Delegated Report

Householder Planning Application

Planning Application No: 20230073

Description: Formation of a vehicular crossover and dropped kerb with associated hardstanding area. Enlarge opening in existing front wall to give access to new parking area. Erection of a single storey extension to the existing rear garage to be used as storage and a garden room.

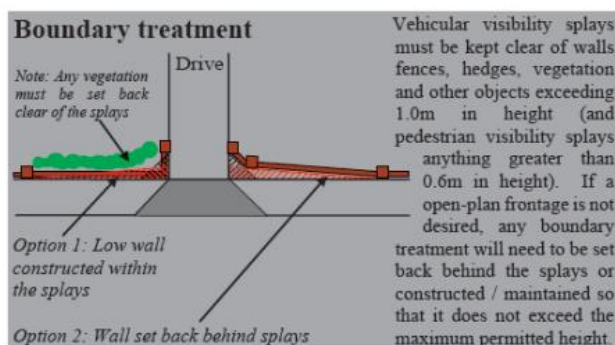
The applicant has shown the pedestrian visibility splay in the wrong place, it should be within his site boundary, at the boundary between the highway or amenity space and his property, subject to this revision I would have no objections.

The visibility splay is generally measured from the back edge of highway, footway (or verge) as appropriate.

I have no idea of the status of the verge, but it is open ground and so can be used by the general public for dog walking etc. I also note that outside the neighbour's there is a lamp column and what appears to be a manhole in the grassed area, both of which suggests it is highway, even if the applicant may own it. There is also a telegraph pole further down the road in the verge and none of the drives have a demarcation strip at the back edge of footway, all of which supports the highway theory. Finally in the same verge but in Upper Avenue there is a salt bin, utility cabinet, and a street name plate all located in the verge. So, the visibility splay is as per my drawing.

A revised plan with the correct vision splays was received on 16th March 2023 which address the Highways Officer's concerns.

Google Street View May 2019.

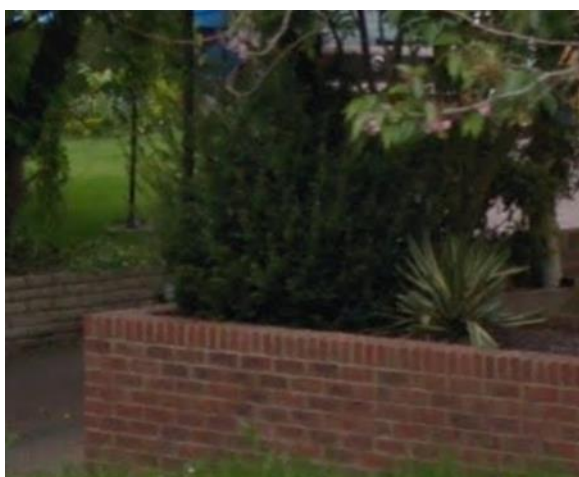
Now a UK brick size is 65mm high by 102.5mm wide and 215mm long so nine courses of bricks plus the capping brick is 687.5mm to which must be added the mortar joints of which there are 10 and if each layer averages 5mm then an additional 50mm must be added given approximately 740 mm height for the wall, so the proposed wall height is the same as the existing one.

Anyone using the verge for dog walking should have the animal on a lead given the proximity of the carriageway and the fact that drives regularly cross the verge. Other activities are less likely due to the verges width and the proximity of the carriageway and the variable nature of verge maintenance which suggests the adjacent properties may trim the verge at intervals.

My view having carefully considered the matter is a wall height of 740mm is acceptable, but there should be an overall limit on landscaping within the visibility splay to a maximum height of 850mm, which will be a significant improvement on the existing situation which cannot be controlled and in 2019 at least was obstructed by a bush/hedge.
